Regulation No. 99 (Gas-discharge light sources)

Proposal for Supplement 7 to Regulation No. 99

Submitted by the experts from the Working Party “Brussels 1952”*

The text reproduced below was prepared by the expert from Working Party “Brussels 1952” (GTB) in order to introduce new categories of gas discharge light sources D5S and D6S in this regulation. The modifications to the existing text of the Regulation are marked in bold for new characters.

CATEGORY D5S

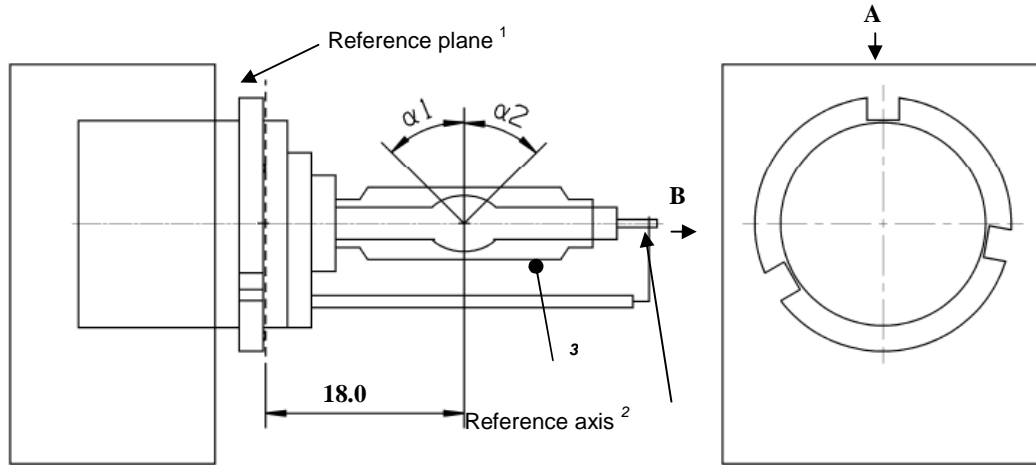
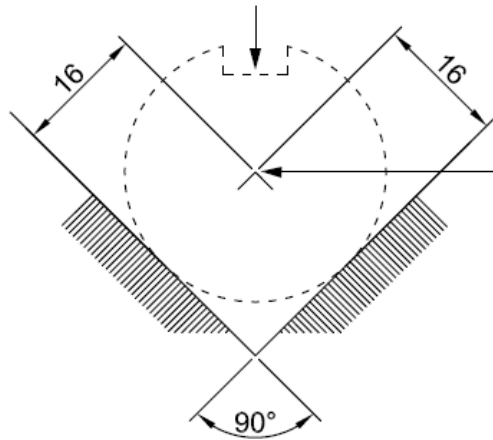
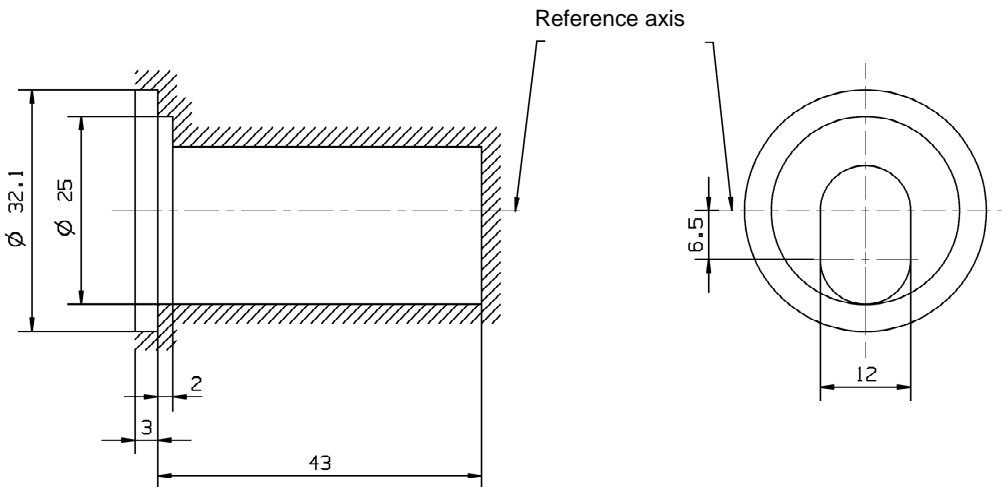
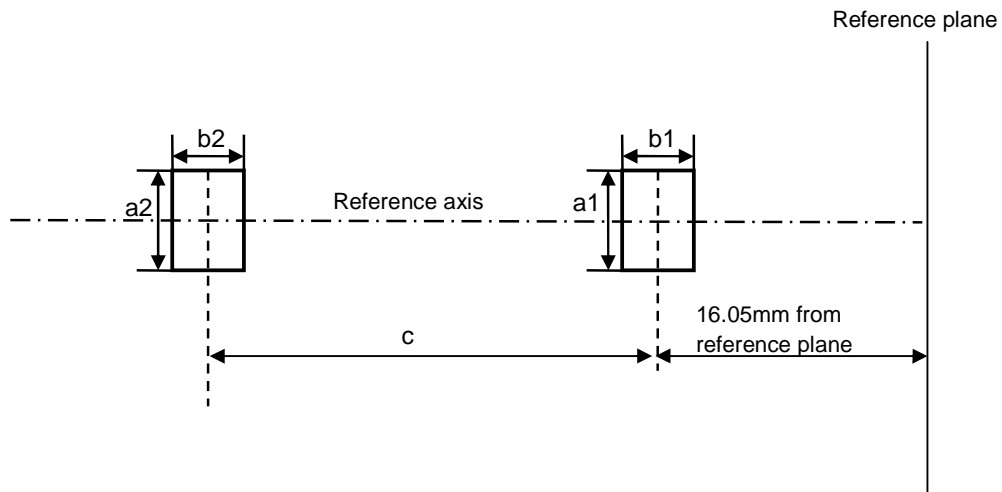
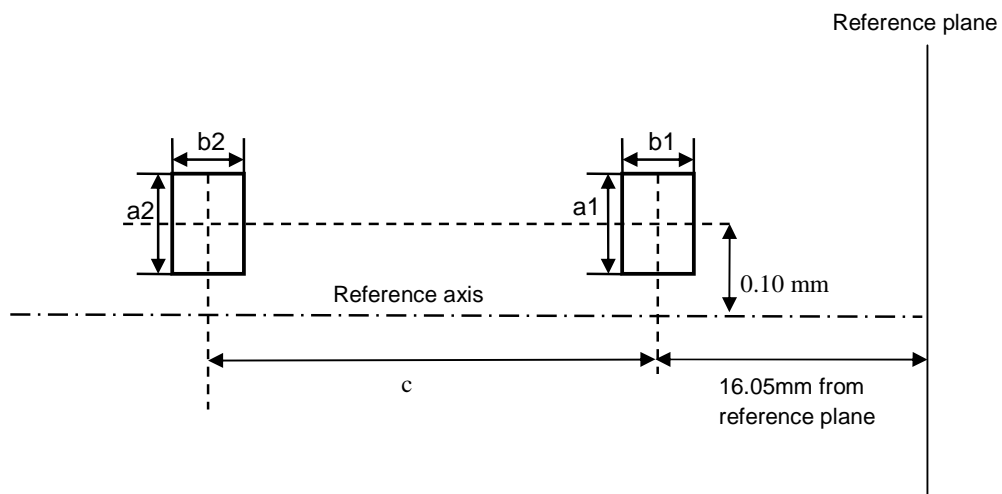
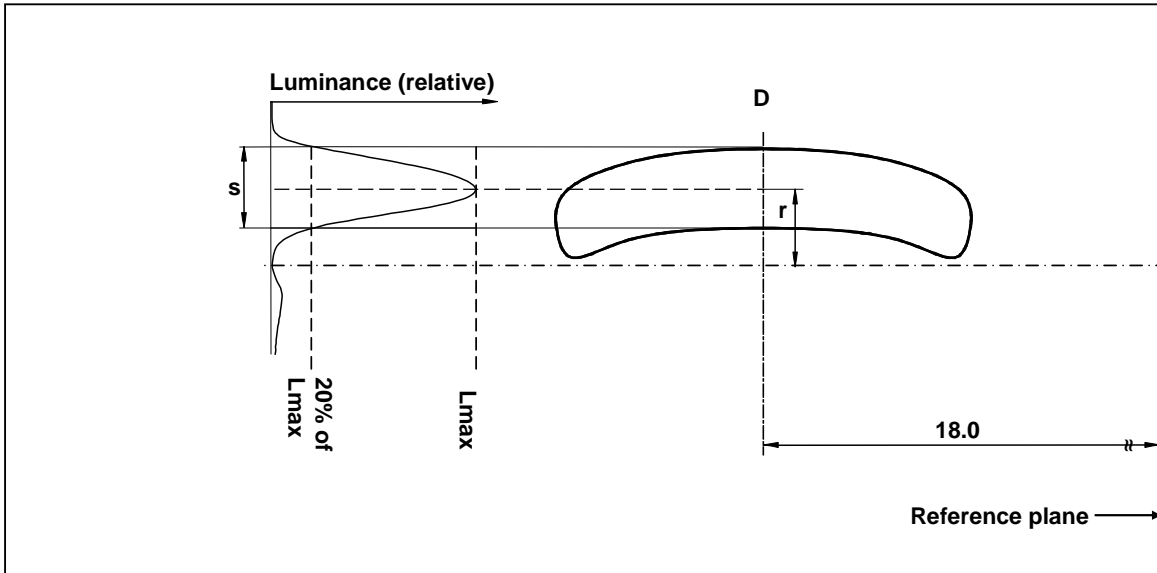
Insert new sheets D5S/1 to 5, to read:

1. This is a proposal introduces new categories of gas discharge light sources D5S and D6S according to the latest, high efficiency, mercury free technology, providing 2000 lm at 25W. The main target is middle class vehicles, today equipped with halogen headlamps. Application in these vehicles without additional installation requirements allows for a higher illumination on the road at lower power consumption. This is beneficial to both traffic safety and environmental protection.

2. D5S extends the existing range of D1S and D3S categories that have the starter integrated with the light source, where the ballast is a discrete component. In the case of D5S however, the ballast is integrated with the light source, too. A high voltage connection is thus avoided; only a 12V input is necessary. D5S is very compact, which results in less volume and build-in depth of the headlamp under the hood. The low volume may also be attractive to motorcycle headlamps.

CATEGORY D6S

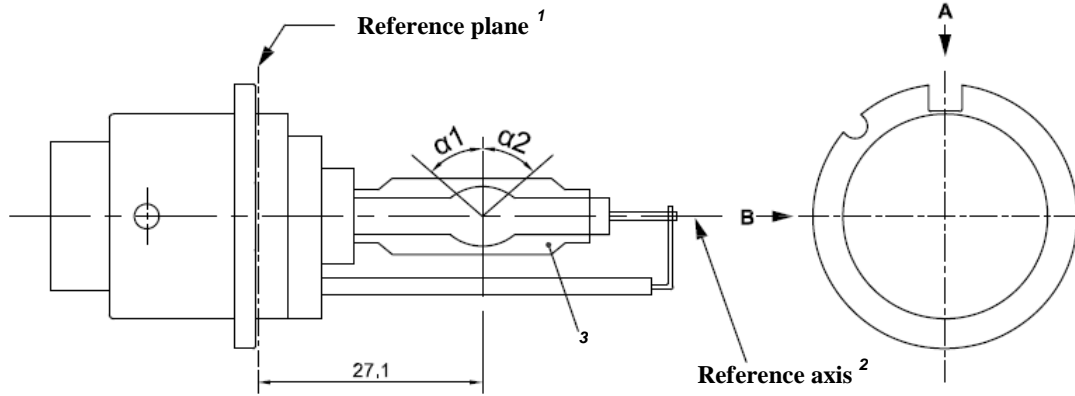
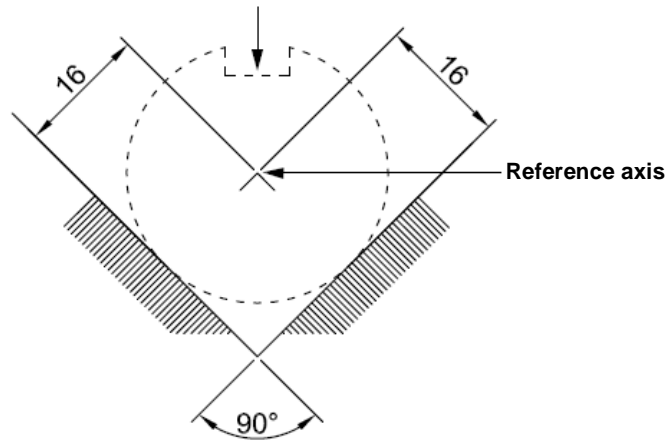
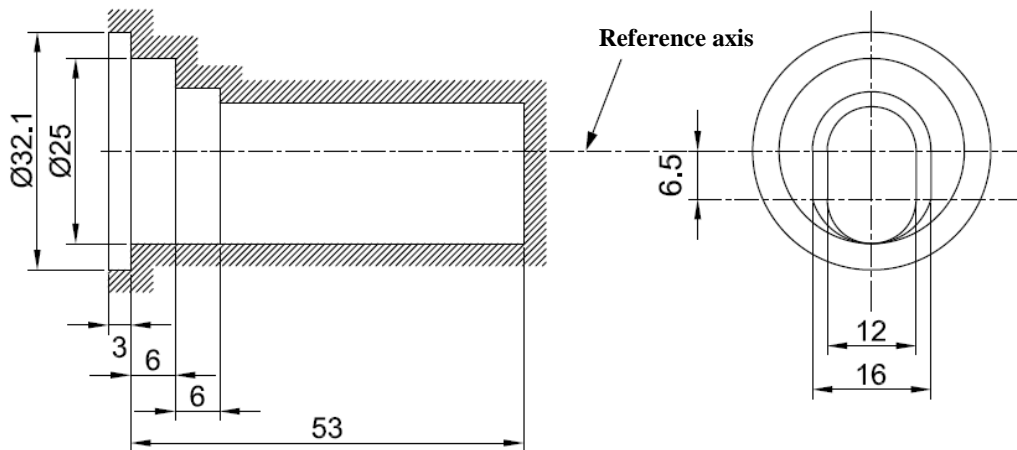
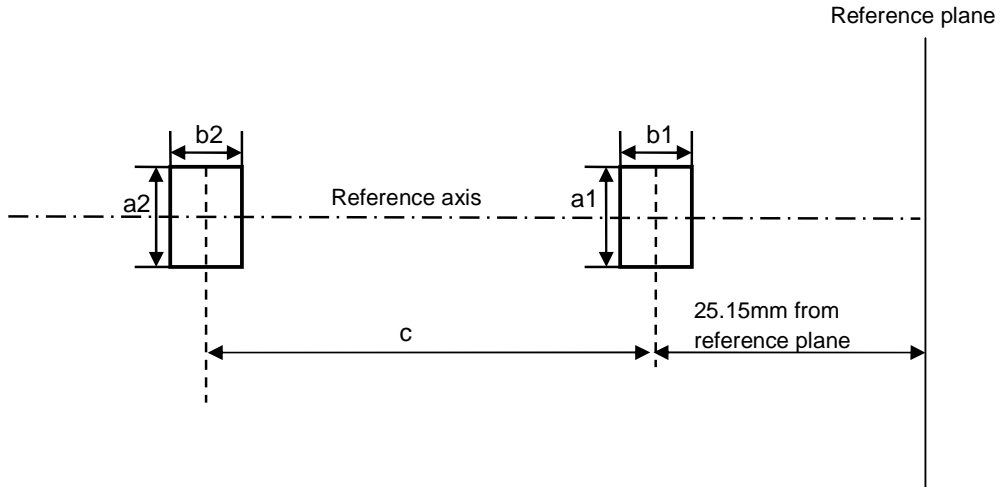
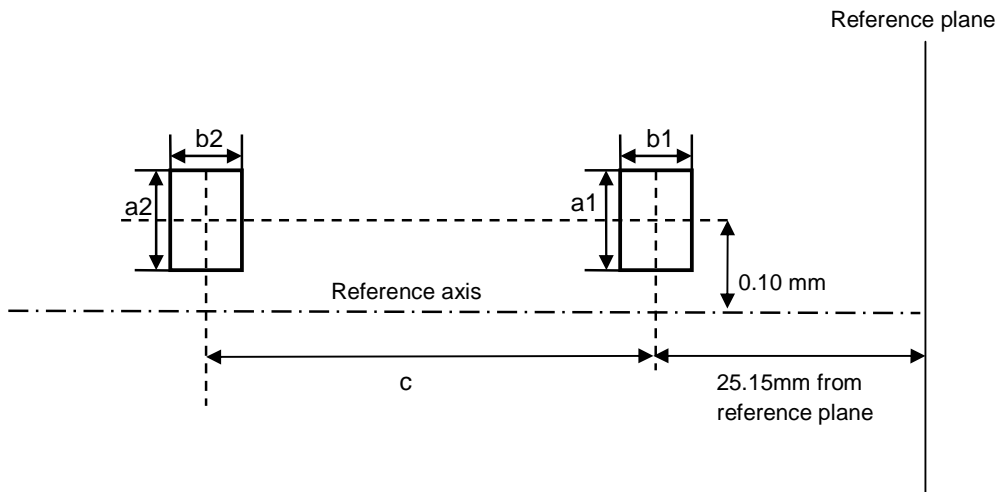
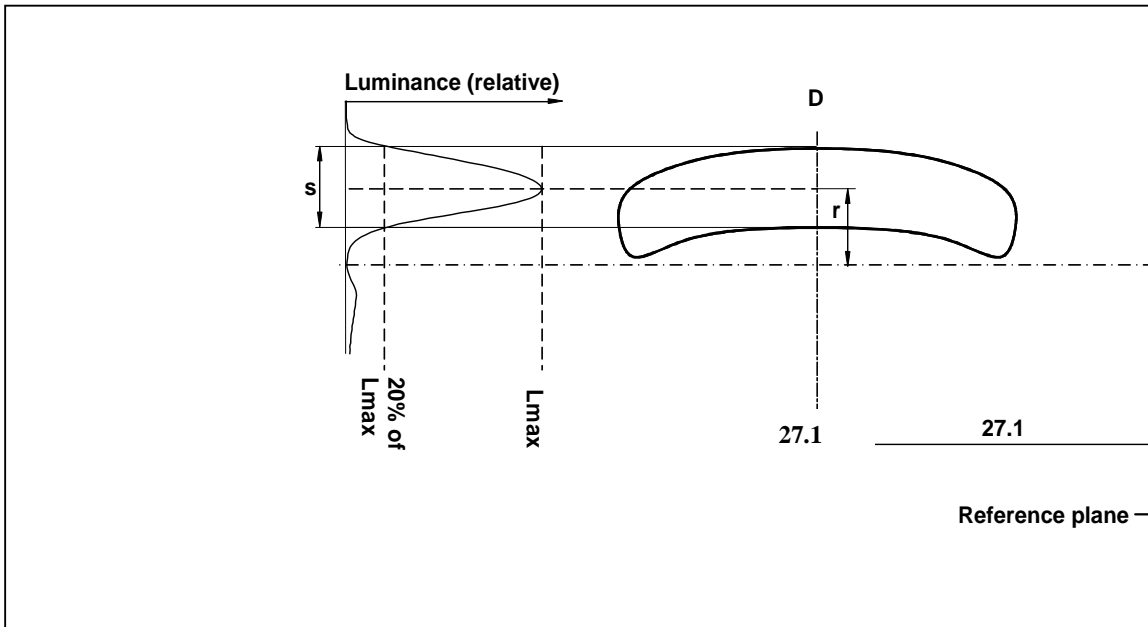
Insert new sheets D6S/1 to 5, after sheet DxS/6, to read:

3. D6S extends the existing range of D2S and D4S categories, where the starter and ballast are discrete components. Hence components can be replaced each when necessary. Proposals specifying cap/holder details are under consideration by International Electrotechnical Commission (IEC).
